Richland Operations Office Plutonium Finishing Plant Closure Project

Electrical Safety DNFSB Briefing

December 4, 2008

Unprotected 291-Z 480-Volt Switchgear

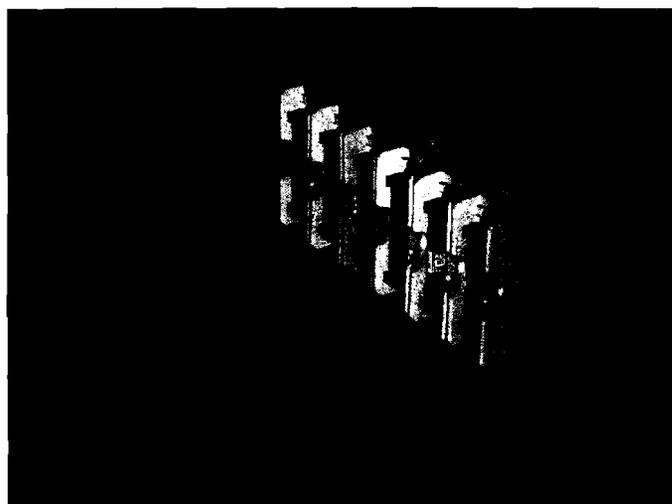
Concern: Water could have leaked inside the switchgear. PFP agreed to evaluate the switchgear for damage.

- **Switchgear inspected for damage, June 2008 (see photo's)**
 - No indications of damage were found
 - Water stains occurred several years ago during maintenance activities
 - Roofing inspections were conducted in July and November 2008
 - Removed water stains and painted to detect any future leaks, completed September 2008
 - Identified water leaks are being sealed (currently underway)

Hydrogen Accumulation Hazard in 234-5Z Switchgear Battery Room

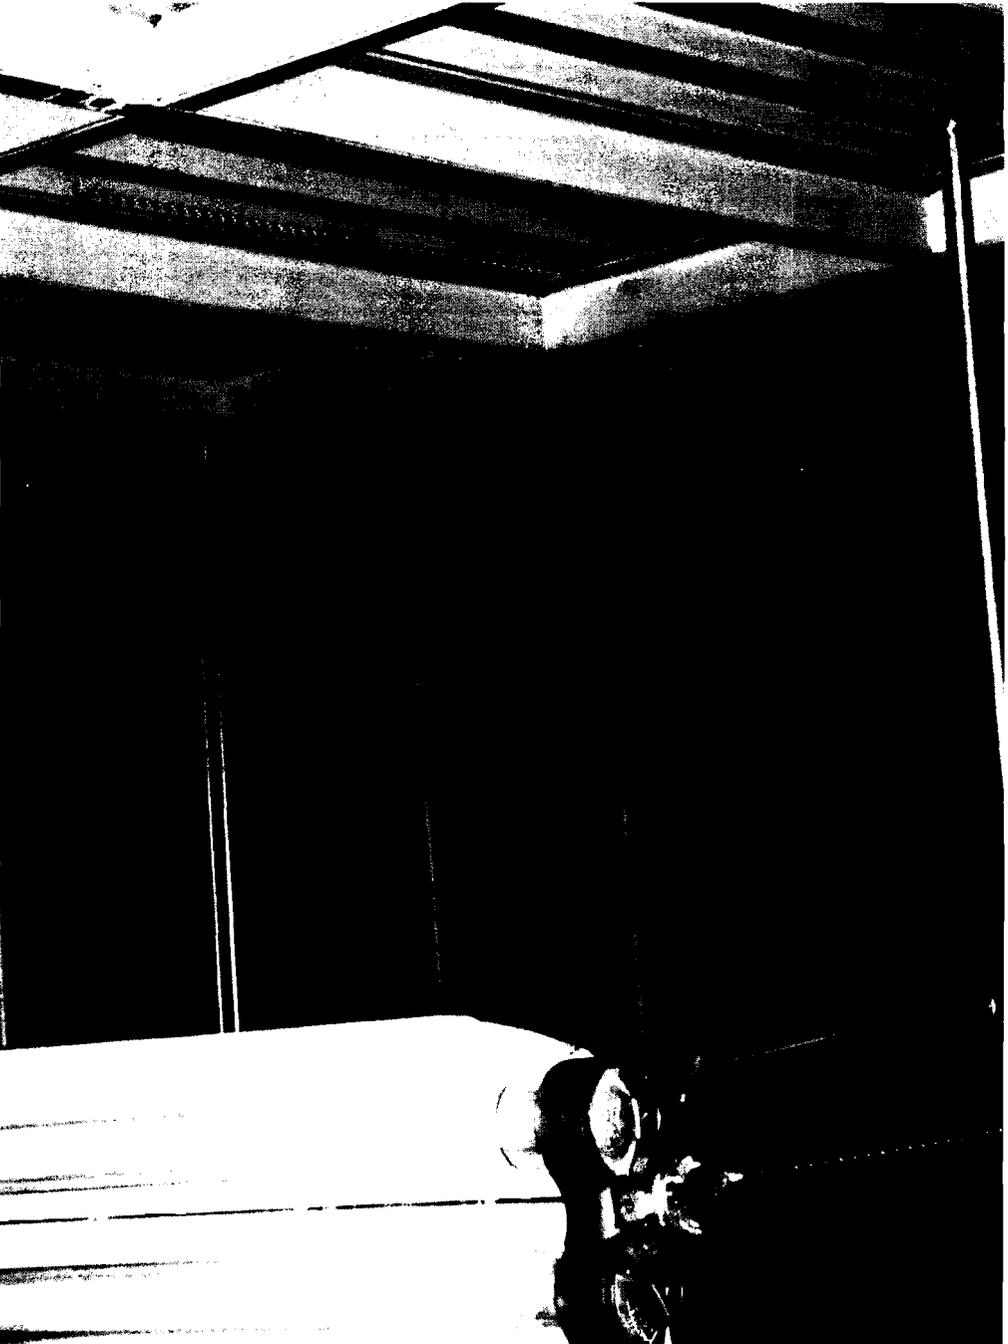
Concern: PFP evaluate design modifications to prevent hydrogen accumulation in the space between the duct and the ceiling in room 269.

- Hydrogen accumulation surveys, August 2008
 - No flammable gas detected
- Ventilation exchange rate survey, August 2008
 - High exchange rate
 - Active ventilation between duct and ceiling
- Low Hydrogen generation from batteries, per manufactures information
- Annunciation in 321 Control Room upon charging system failure
- Regularly scheduled checks of batteries (electrolyte, cell voltage, charging system, etc.) are conducted

Modifications are not needed to prevent accumulation of hydrogen in room 269.
